SHOWING PROPOSED BUILDING
ON PLOT NO. 144 AMBRACKMENT ROAD
NAPIER QUARTERS
SCALE 8 FT = 1 INCH = 79.8 CM

KMR.CDD.NaQ.1916.04

Plans for plots No 111, ^A114 & 107, A-21 Napier Cr.

PLAN

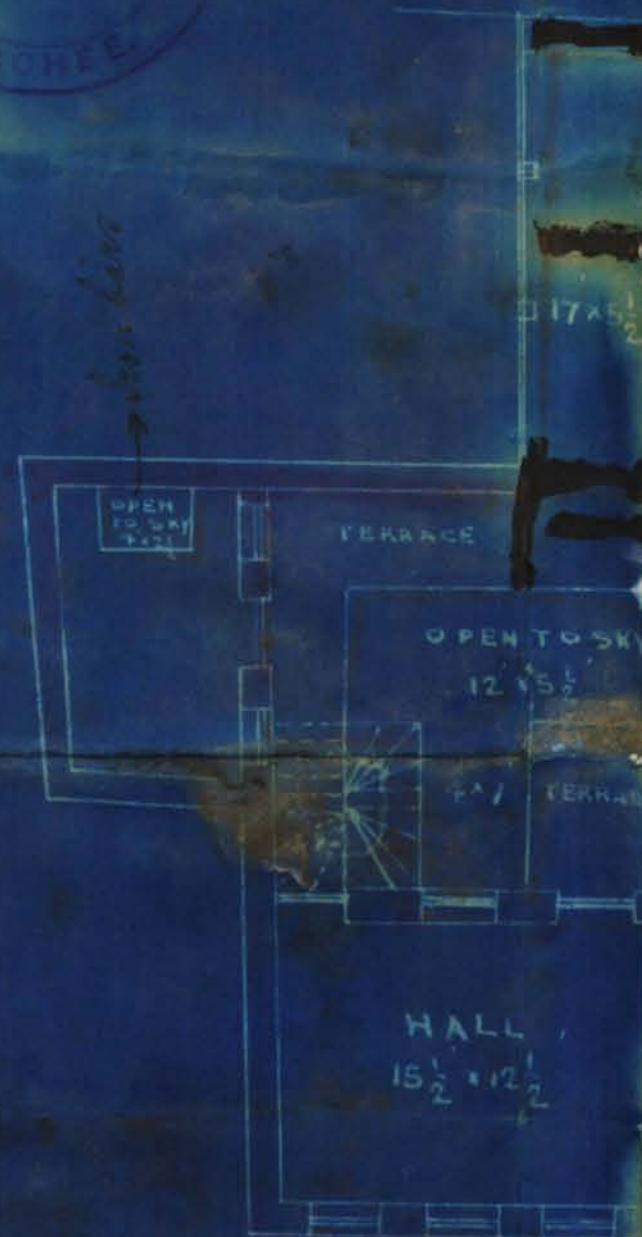
Could not the owner be required to submit what amendments you require so far as the buildings are concerned. The room 5½ feet wide over the passage does not appear to be satisfactory, and Undersigned should say should be omitted, altogether and only a passage provided.

*will be
rooms are bad & ventilated*

SITE PLAN

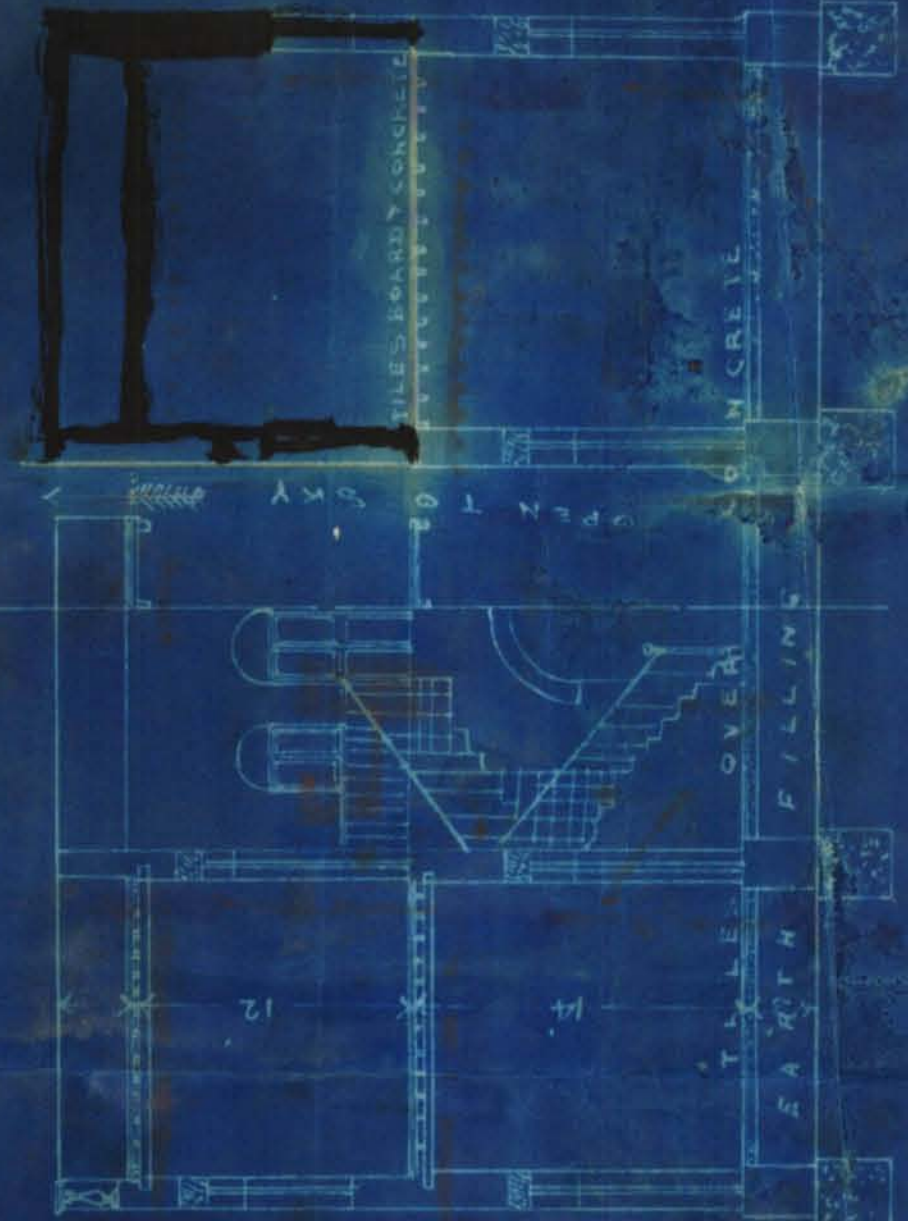
Block plan does not show the existing plot of affairs.

With reference to his application dated 4th inst. regarding building on plot No. 111 & 114/A, A-21 Napier Quarter Mr: Kazi Abdul Karim is informed that the plan submitted does not agree with the plots shown on the Survey Sheet.

A correct block plan the plots with any existing buildings must be submitted before the matter can be dealt with.

With reference to his application dated 16th June 1916 with a set of amended plans for building on plot Nos: 114 & 111 A-21 Napier Quarter, Mr Kazi Abdul Karim is informed that the site plan as shown on the plan submitted is incorrect. He should bring his architect in the Office to remove the discrepancy shown in the site plan when his application will be further considered.

With reference to his application dated 17th May with plans for building tenements on plot Nos: 111 & 114 A-21 Napier Quarter, Kazi Abdul Karim is informed that the site plan shown does not tally with the plot shown on the Survey Sheet.

The block plan does not show the existing state of affairs. He must get the plot sub-divided before he can be allowed to build in the manner shown.
